WACO TOWNSHIP ADDITION

IN SEDGWICK COUNTY, KANSAS

RE: S/D 98-111-- One-Step Final Plat of WACO TOWNSHIP ADDITION

STAFF REPORT
(One-Step Final Plat Approved 12/10/98)

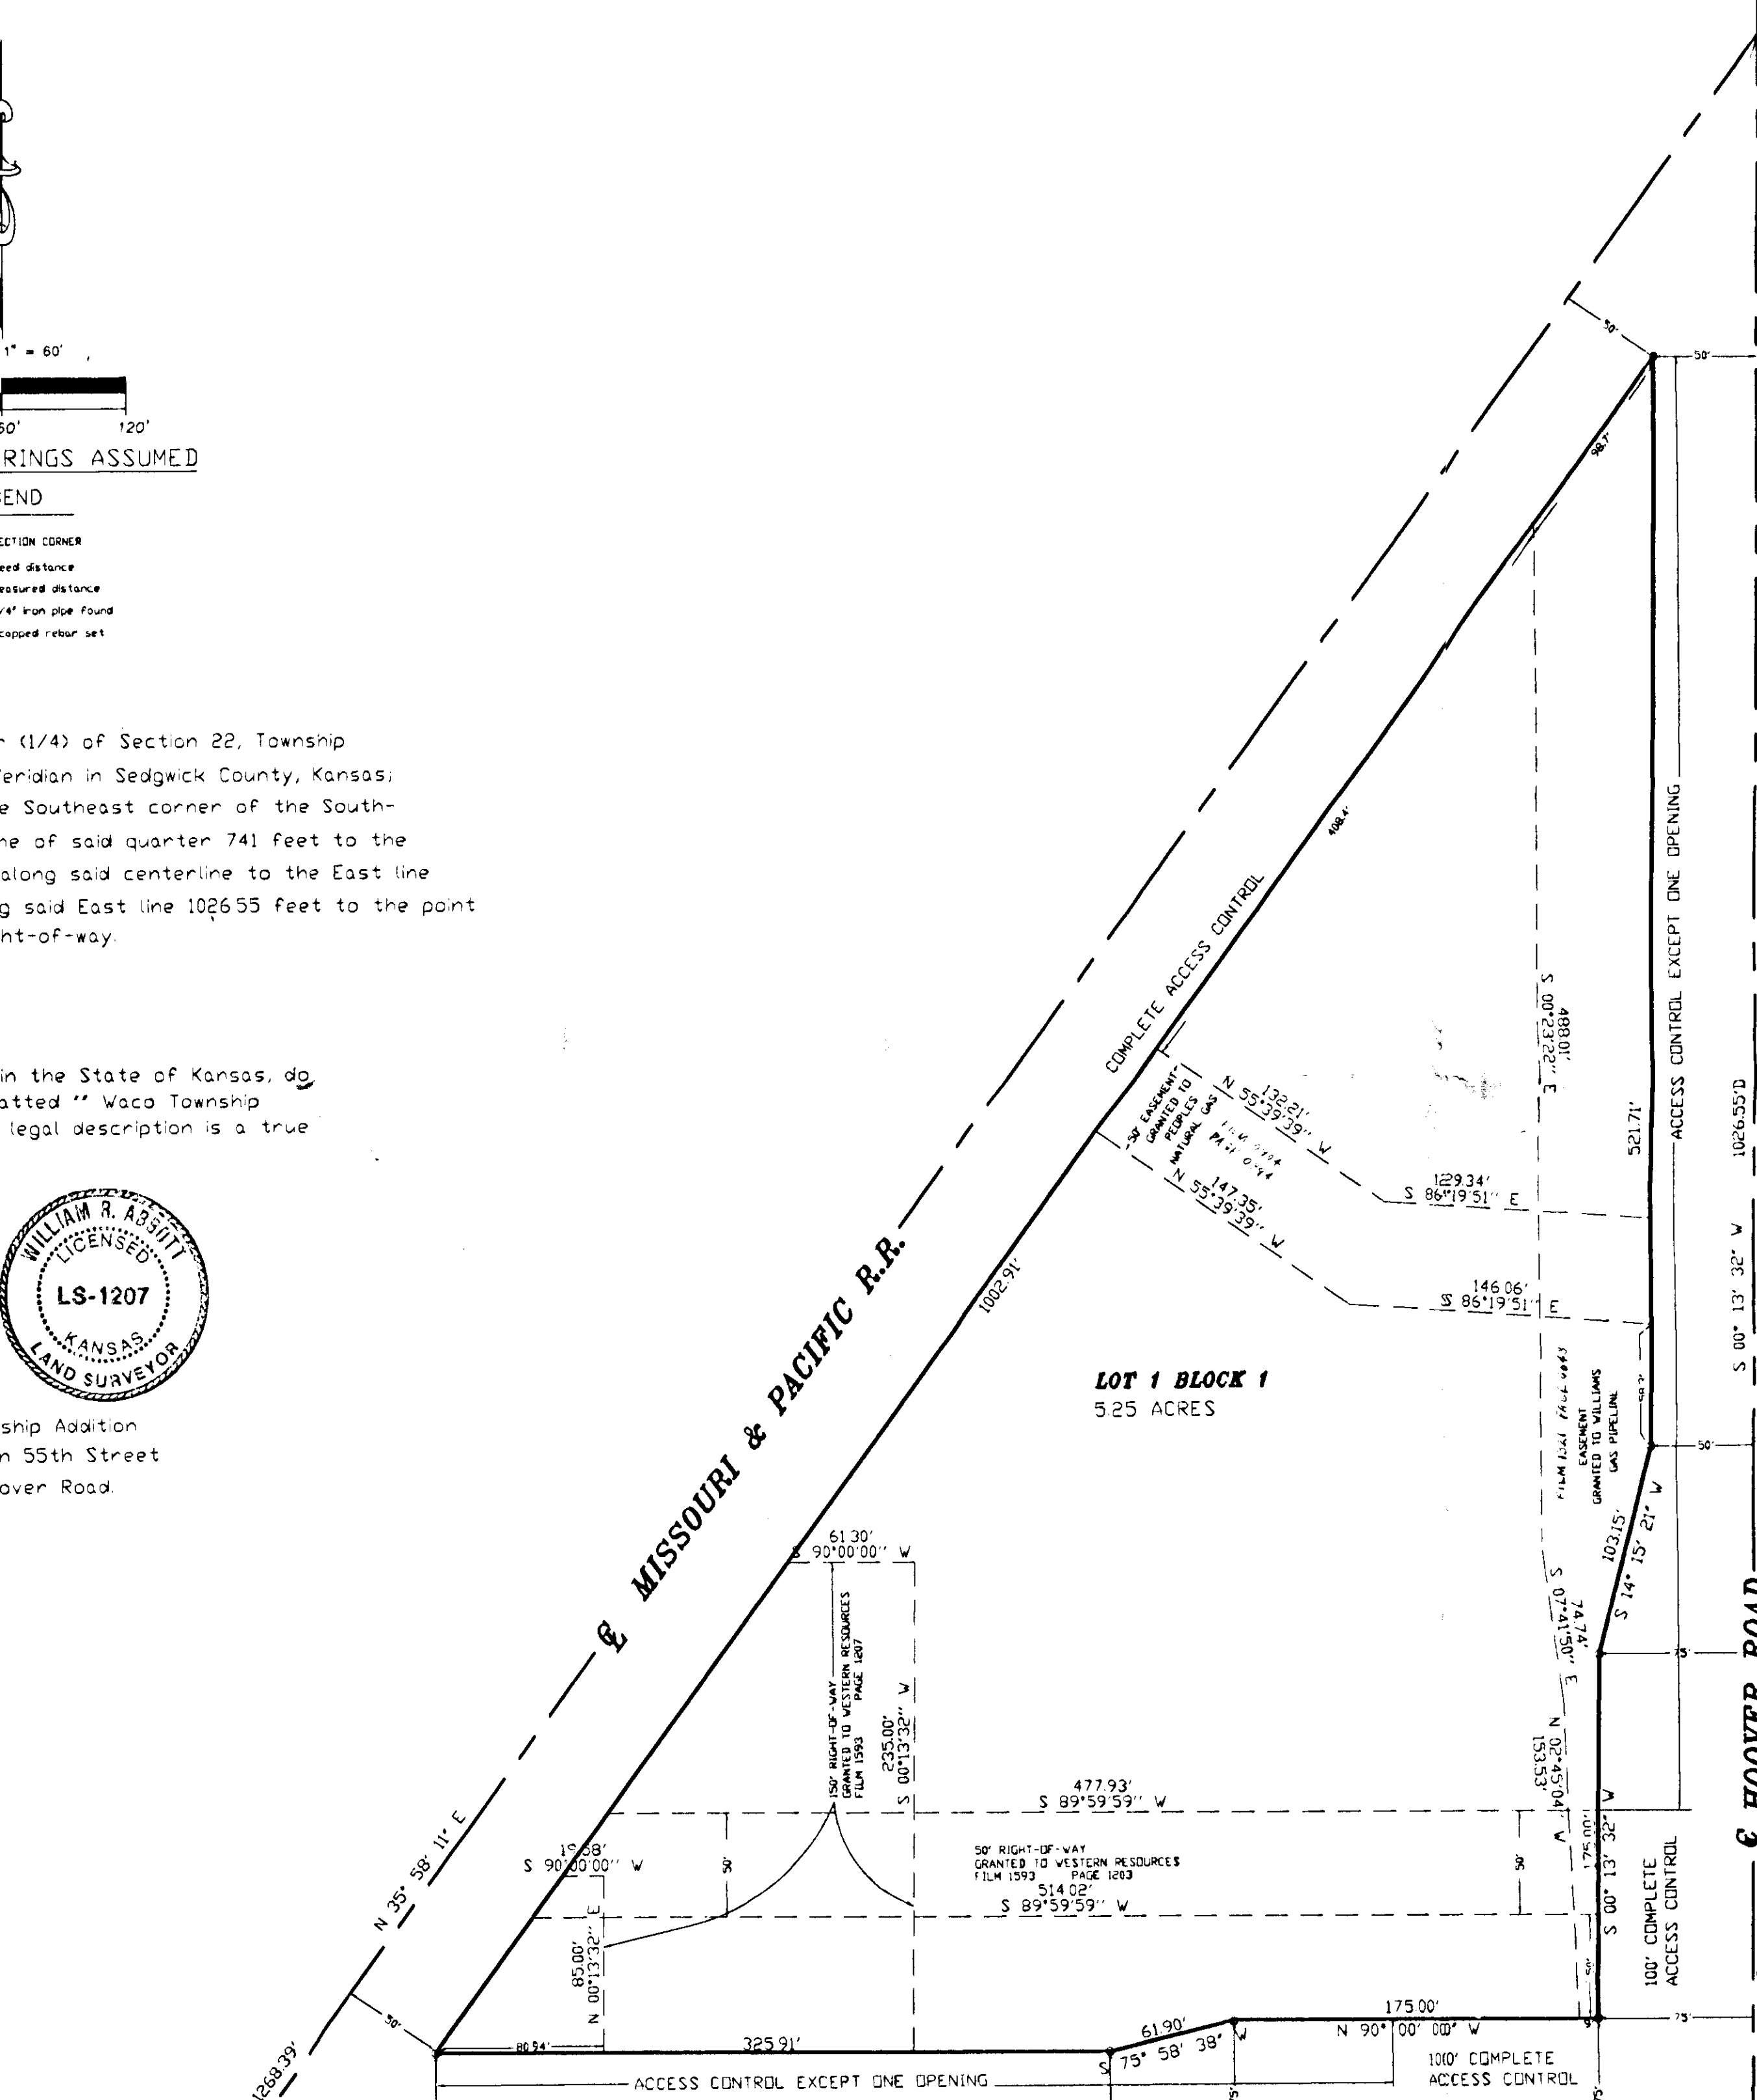
- C. County Engineering needs to comment on the status of the applicant's drainage plan. The drainage plan is approved.
- D. The final plat shall denote access controls along perimeter streets. Distances should be shown for all segments of access control. The dedication of access controls shall also be referenced in the plat's text. County Engineering shall comment on the need for complete access control from the railroad right-of-way and from the 60-ft right-of-way denoted along the southeastern portion of the plat. County Engineering has approved one opening on each perimeter street. County Engineering has approved the vacation of the right-of-way in the southeastern portion of the plat, along with a major intersection right-of-way.

- E. The dedication of additional right-of-way for adjoining streets should be referenced in the plat's text.
- F. The applicant shall submit a copy of the instrument which establishes the pipeline easements on the property, which verifies that the easements shown are sufficient and that utilities may be located adjacent to and within the easements.

- G. The applicant's agent shall determine any setback requirements for the pipelines by researching the text of the pipeline agreements. If a setback from the pipeline easements is provided for in the pipeline easement agreements, it shall be indicated on the face of the plat.

- H. The applicant needs to revise the legal description to accurately portray the land being platted. The distances on the drawing must correlate with those in the legal description.

- I. The MAPC signature block needs to be revised to read, "William M. Johnson, Chairman" and "Marvin S. Krout, Secretary".
- J. The County Commissioners certification needs to be added along with the names of the five Commissioners.

- K. Since the site is within three miles of the City Limits of Wichita, the City Council signature block needs to be included containing the signatures of the City Clerk and Mayor.

- N. The applicant's engineer is advised that the Register of Deeds is requiring the name(s) of the notary public, who acknowledges the signatures on this plat, to be printed beneath the notary's signature.
